NUMBER OF CONNECTIONS

60825

Nissens radiator 60825 covers both first and second version of BMW radiators which have different number of connections.

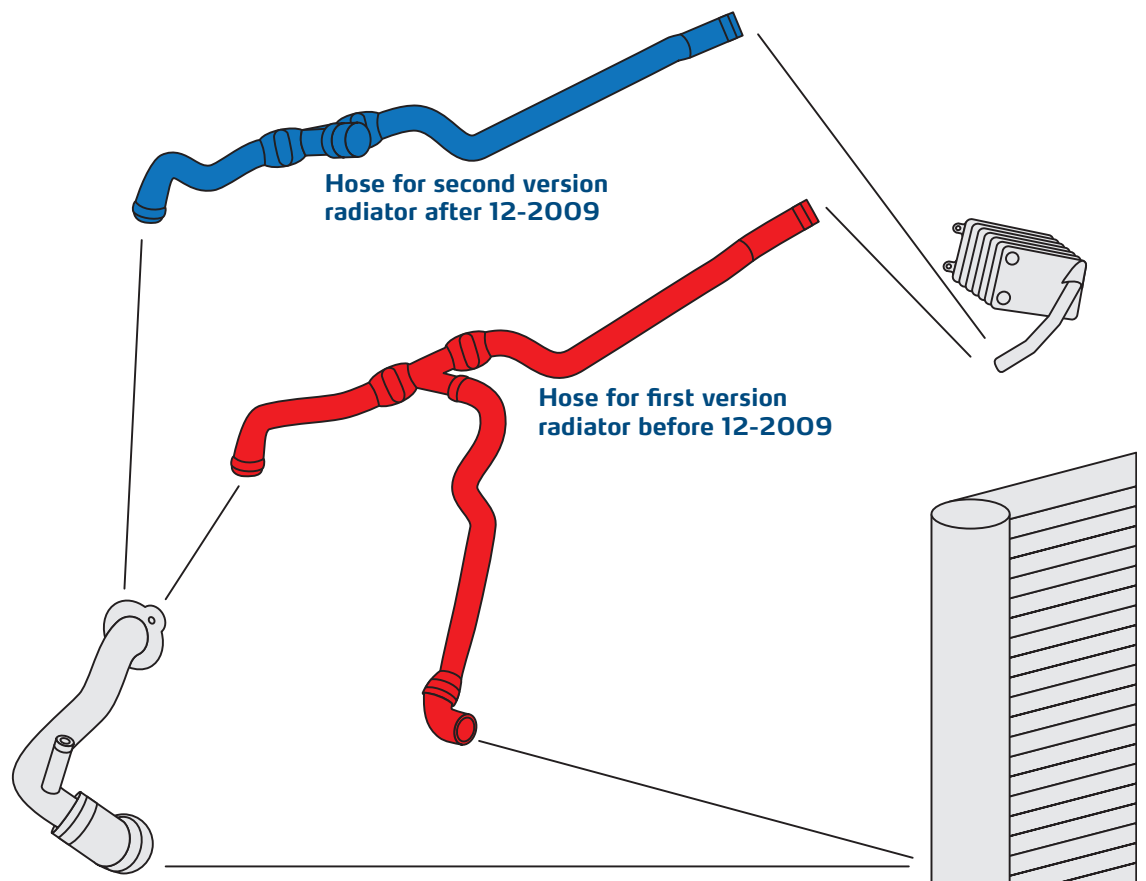
First version radiator: Before 12-2009

The first BMW radiator version had 4 connections used in connection with hose OE 1153 7609 944 (red). This expired 12-2009.

In the first version the hose is also connected to the fourth connection in the radiator.

Second version radiator: After 12-2009

The second BMW radiator version after 12/2009 only has 3 connections used with hose OE 1153 754 7244 (blue).

In the second version the hose is only connected to three connections in the radiator.

Both hose versions are connected to the engine oil heat exchanger and to the water hose.
